# SERVICE BULLETIN

No. 515

Piper Aircraft Corporation

Control Cable Ball Joint Retainer Installation

TYPICAL BALL JOINT RETAINER INSTALLATION

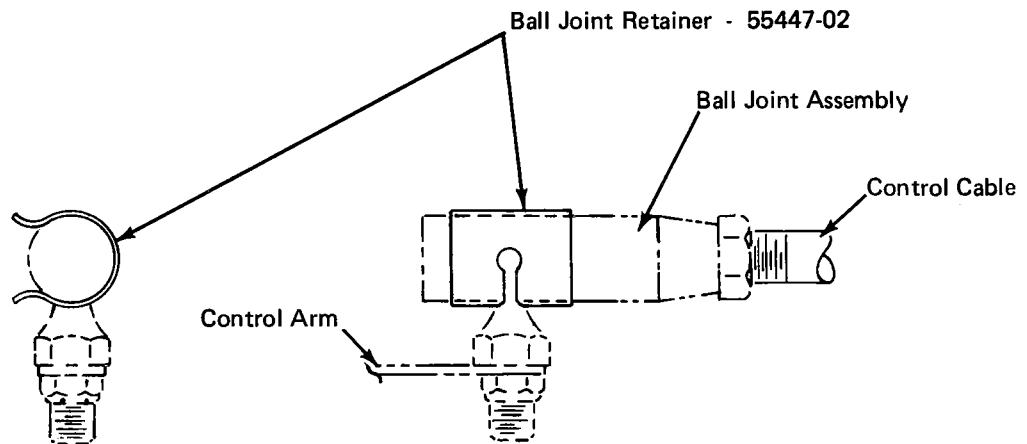
Purpose: There have been a few reports received from the field describing inadvertent detachment of the engine controls (i.e., throttle, prop governor and/or mixture) at the control cable ball joint attachment assembly. Failure of this ball joint assembly renders the particular control system inoperative. Although these ball joint attachment assemblies are subject to routine inspection, per published Piper inspection data, excessive wear - over a prolonged period of operation - in conjunction with inadequate inspection of this area - can permit detachment of the ball joint "ball" from its mating socket.

This service release announces availability of a safety device (retainer) that, when installed on the ball joint assembly, prevents disengagement of the ball from the socket (attached sketch/instruction sheet illustrates a typical ball joint assembly retainer installation).

1. Install ball joint retainer 55447-02, as shown above, to the control cable ball joint assemblies located in the engine compartment. See list below for appropriate model, control cable and quantity per airplane.

2. Install ball joint retainer 55447-02, as shown above, to the control cable ball joint assemblies located in the engine compartment and cockpit fuel control panel for the PA-31T. See list below for control cable and quantity.
